Item 6.**Development Application: 371-375 Pitt Street, Sydney - D/2020/334****File No.:** D/2020/334**Summary**

Date of Submission:	The application was lodged on 14 April 2020. Amended plans and documentation were submitted on 31 July 2020.
Applicant:	Sydney Redevelopments 1 Pty Ltd
Architect:	Crone Architects
Owner:	Sydney Redevelopments 1 Pty Ltd
Cost of Works:	\$80,449,000
Zoning:	The site is zoned B8 - Metropolitan Centre under the Sydney Local Environmental Plan 2012. The proposed uses comprise retail and hotel accommodation, which are permissible with consent in the B8 zone.
Proposal Summary:	<p>The application seeks consent for a Stage 2 development application, for a 34-storey hotel development, providing 304 rooms, associated hotel facilities, a ground floor retail use, and 2 basement levels.</p> <p>The application is Integrated Development requiring approval from the NSW Office of Water under the Water Management Act 2000. General Terms of Approval were received from Water NSW on 2 June 2020.</p> <p>This detailed design development application is in accordance with concept development application D/2017/920/B which is presented to the Central Sydney Planning Committee (C

Figure 48: Proposed waste collection arrangement, with bin hardstand area and existing loading zone labelled

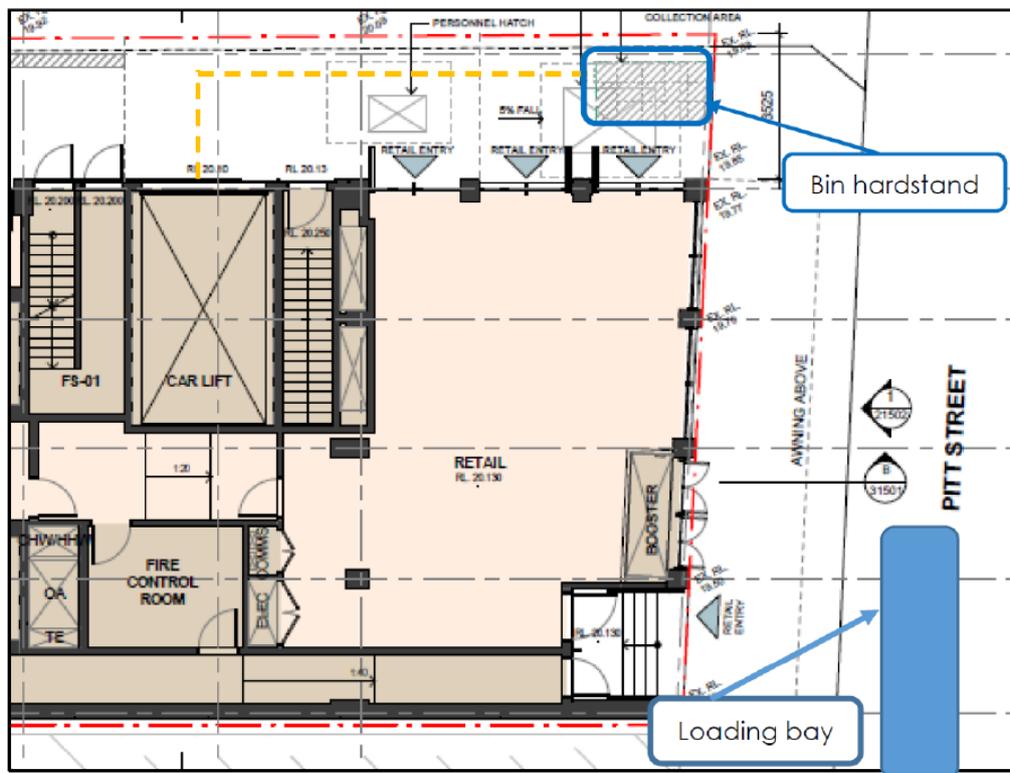
73. Garbage trucks are not able to access the site based on the constraints of the existing Right of Way and site, and are proposed to be undertaken on the street. Collection will occur on the existing loading zone at the site's frontage, with bins wheeled from the bin presentation point at a hardstand area towards the eastern end/Pitt Street frontage of the extended laneway. The waste will remain in this location for only a short time after being transferred from the permanent storage area in Basement Level 1. Figure 48 illustrates the described arrangement.

75. With the subject application, Council's Traffic Planner and Waste Management Officer have reviewed the proposed arrangement and consider it acceptable in this circumstance, for the following reasons:

76. A detailed loading and servicing management plan and updated waste management plan are required as conditions of consent, to ensure that the waste collection will operate in an appropriate manner and will not cause any issues to the future operation of the site, nearby properties and the public domain.

Figure 49: Signage Strategy extract of northern elevation. Signs not supported are circled.

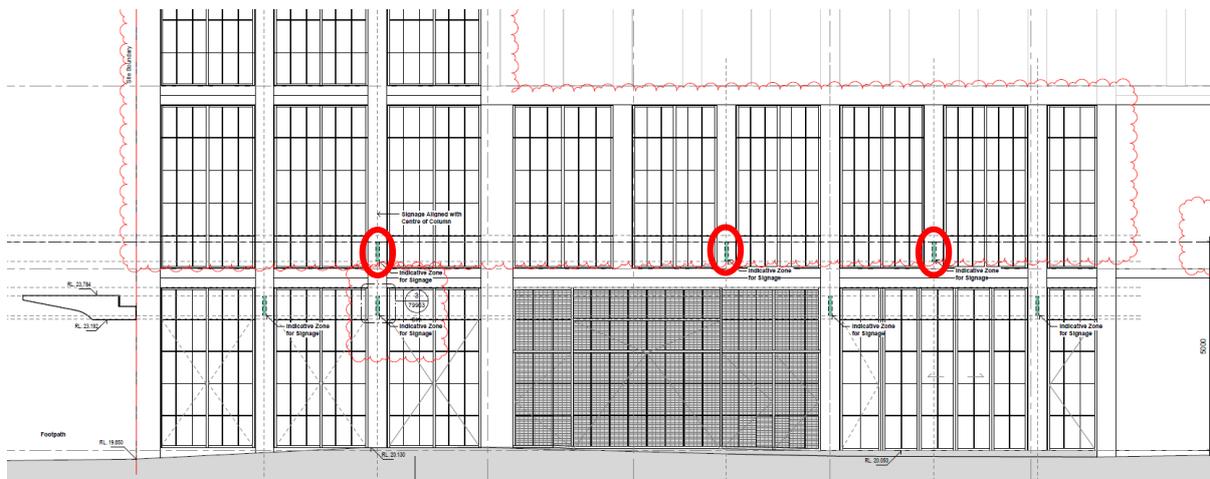
85. In consideration of the objectives and provisions of Section 3.16 of Sydney DCP 2012, the proposed signage strategy is generally acceptable, excluding the three projecting wall signs at first floor level along the laneway (as shown in Figure 49), for the following reasons:

- Although these signs are located along the northern/laneway elevation and not the Pitt Street frontage where the awning is located, these signs are located above the height of the proposed awning which do not comply with the control. Further, these 3 first floor signs in addition to 4 ground floor project wall signs create visual clutter along the northern façade. 7 signs along the laneway is not considered necessary for the one retail tenancy and hotel use.

86. As such, these first-floor signs are not supported. Conditions of consent are recommended for an updated signage strategy to be submitted and approved by Council prior to the issue of a Construction Certificate.
